Stage 2 – Independent Daylight Review Report for Oxygen Towers, Store Street, Manchester M1 2FU

Stocktons, 140 Great Ancoats Street,
Manchester M4 6DU

Project Number - EKA251011

17 December 2025

7.0 Existing vs Proposed

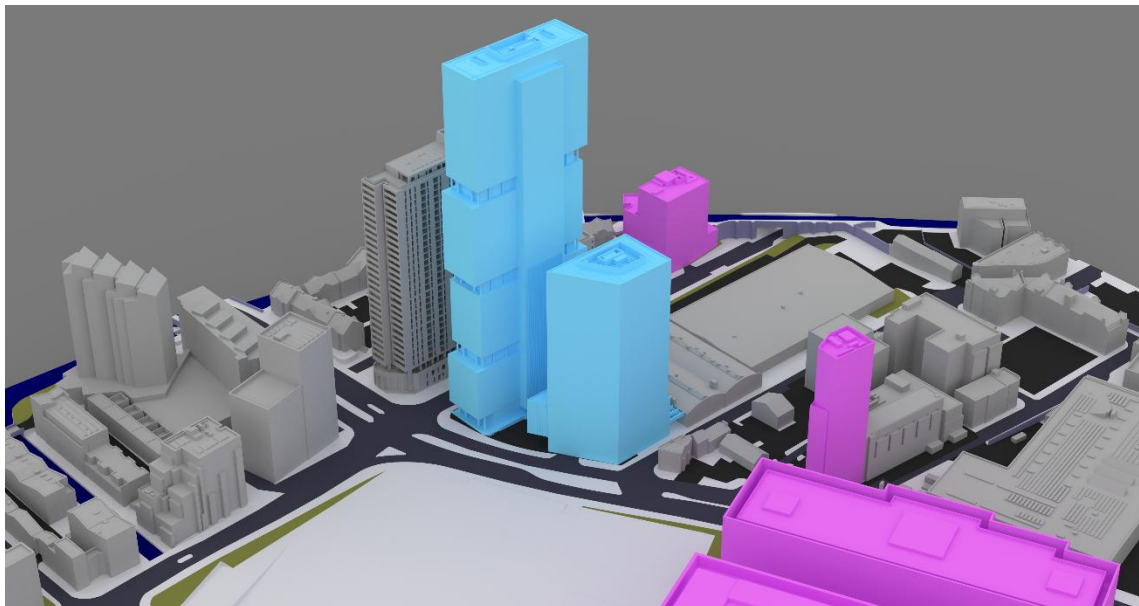
This scenario covers the true impact residents will face upon completion of the development if granted consent.

8.0 Mirror Mass vs Proposed

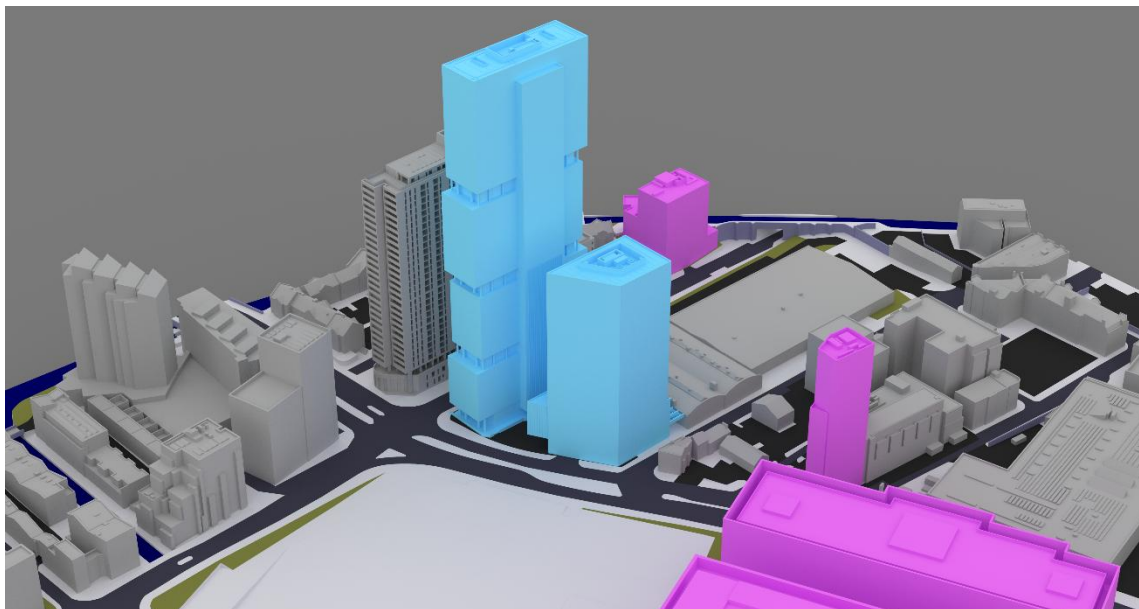
This scenario covers a hypothetical scenario devised by the BRE to set an alternative benchmark massing for alternative baseline figures to work to, in this instance I disagree with this approach as it is not appropriate given the magnitude of the results. This is the angle GIA are trying to justify within their DSO Reports.

9.0 Existing vs Proposed (Plus Emerging Context)

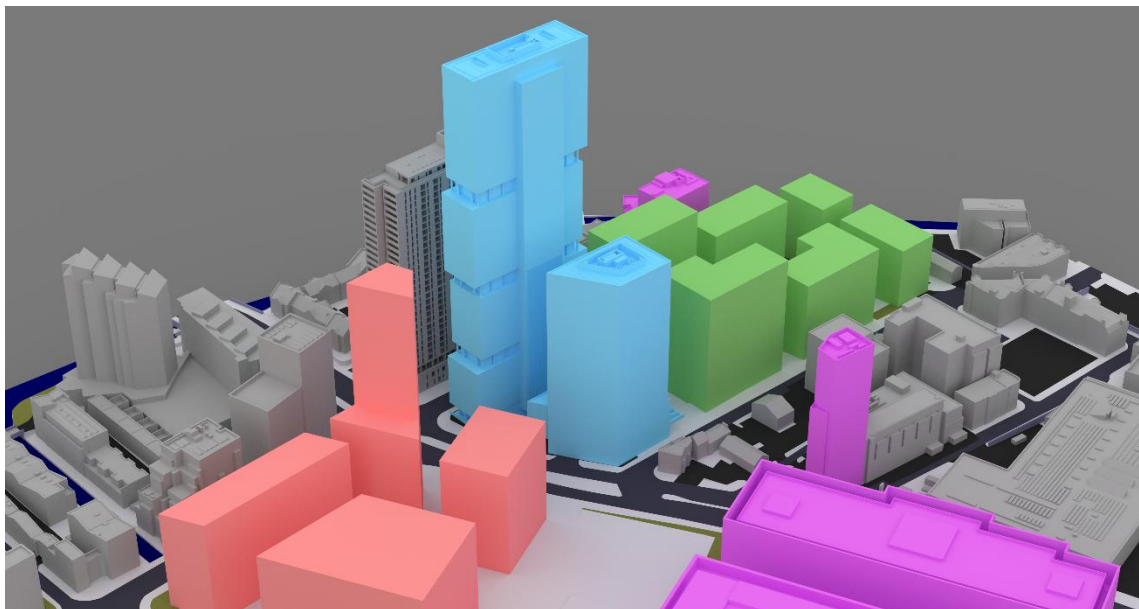
This scenario covers a double whammy, the true impact residents will face upon completion of the development if granted consent plus the additional impact in the future if the emerging context schemes are implemented.

10.0 Mirror Mass vs Proposed (Plus Emerging Context)

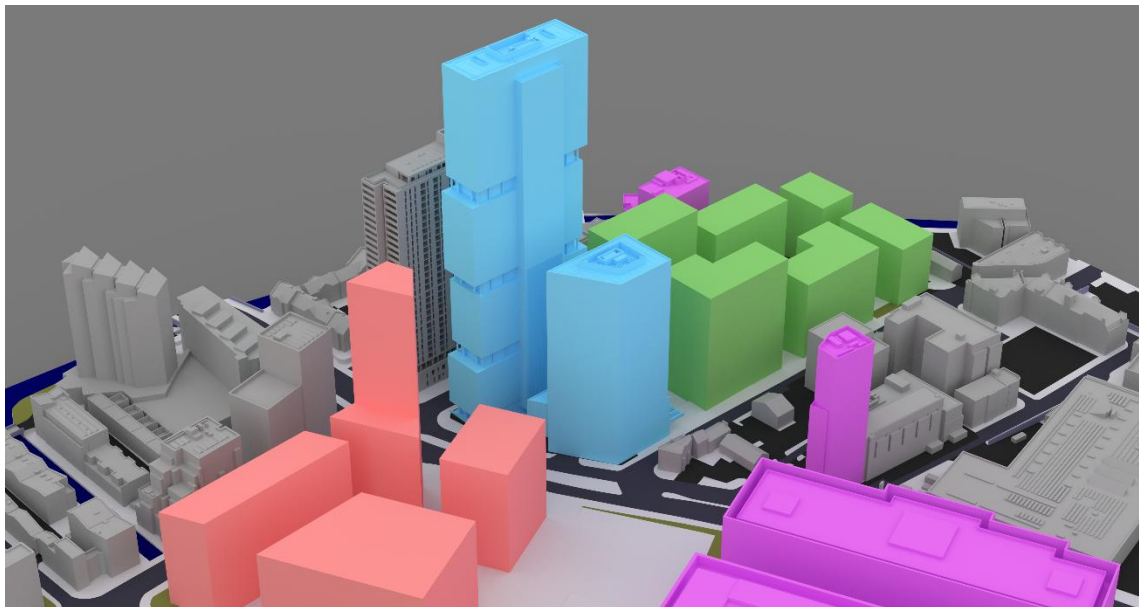
This scenario shows that even with the reliance on Mirror Massing, the scheme will still have an impact in tandem with the emerging context.

11.0 Existing vs Proposed (Serving Suggestion 1)

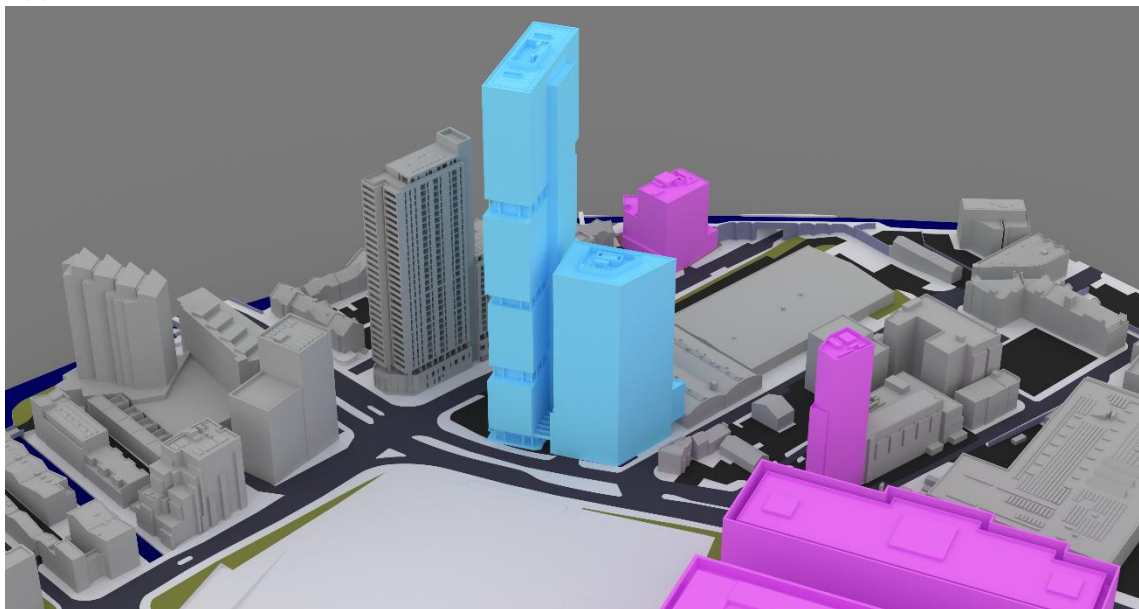
This suggested scenario shows the impact improvement by relocating the footprint of Buildings A and B on a splayed angle away from Oxygen Towers and still achieve the same floor area and units. Building B model has been Mirrored to fit on the site.

12.0 Existing vs Proposed (Serving Suggestion 2)

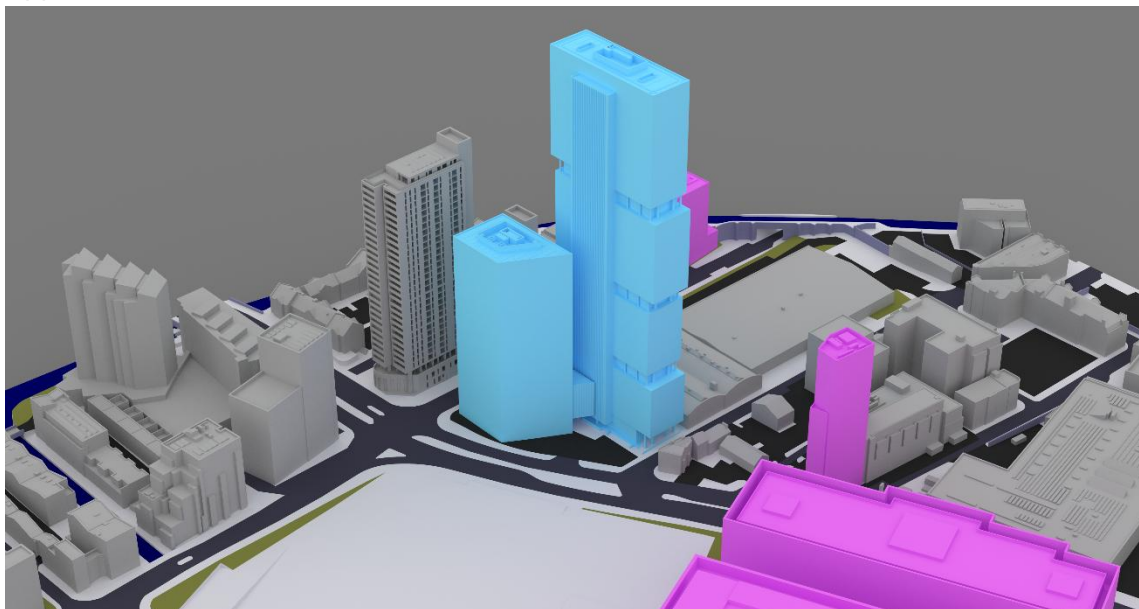
This suggested scenario shows the impact improvement by relocating the footprint of Buildings A and B on right angles away from Oxygen Towers and still achieve the same floor area and units. Building B model has been Mirrored to fit on the site.

13.0 Existing vs Proposed Cutback

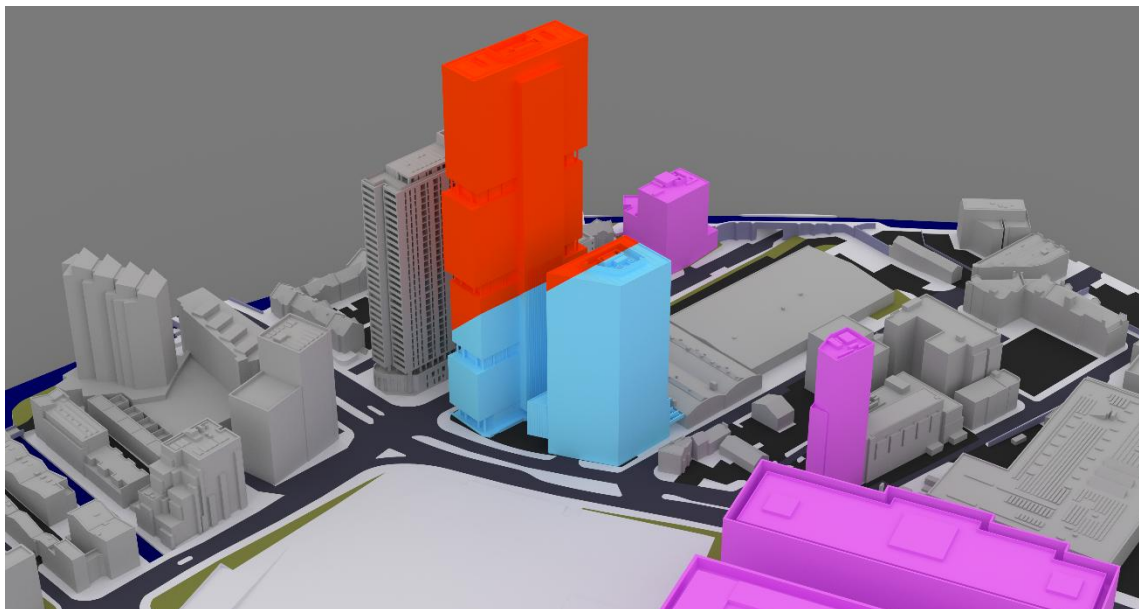
This scenario shows the VSC cut back to leave Oxygen Towers with good retained levels of VSC Daylight. However the cut backs will need to be far more severe if the scheme is to meet the VSC Room and Daylight Distribution criteria.

14.0 Mirror Mass vs Proposed Cutback

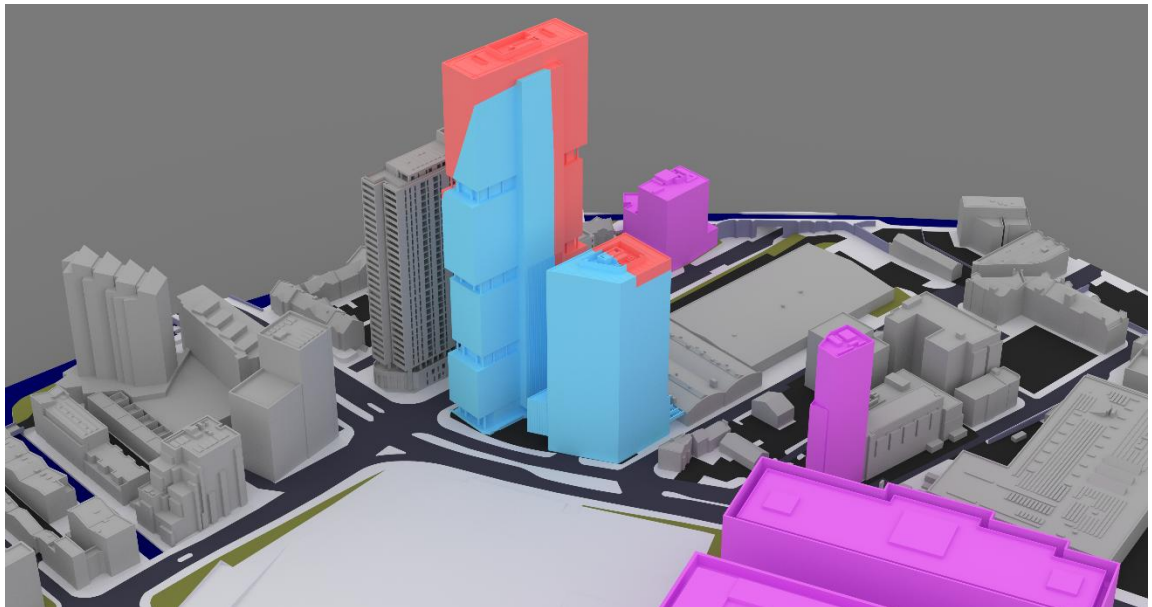
This scenario shows the VSC cut back to leave Oxygen Towers with good retained levels of VSC Daylight against a Mirror Massing baseline. However the cut backs will need to be far more severe if the scheme is to meet the VSC Room and Daylight Distribution criteria. This is the angle GIA are trying to justify within their DSO Reports.

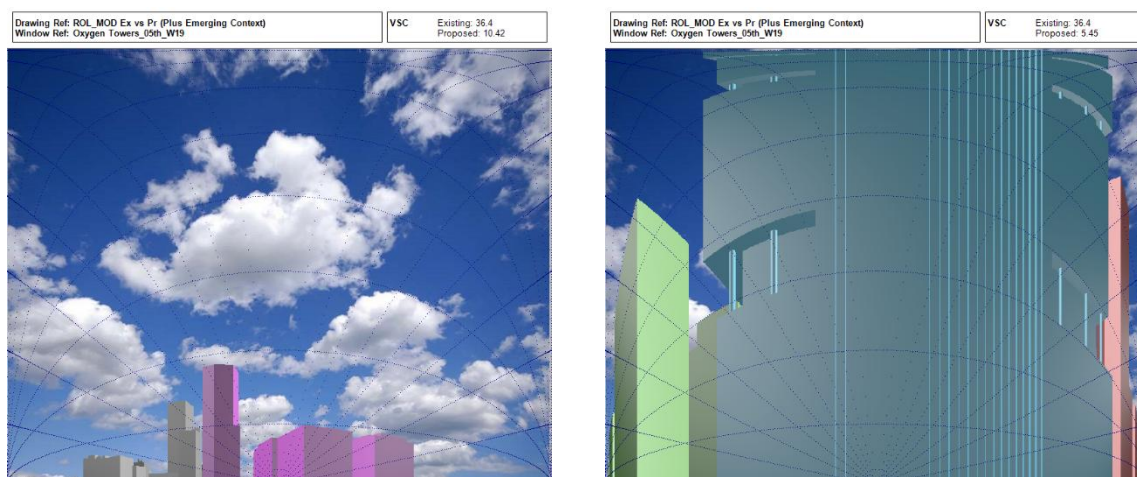
The image above left is the existing VSC Waldram, the image above right is the identical window with proposed plus emerging context.
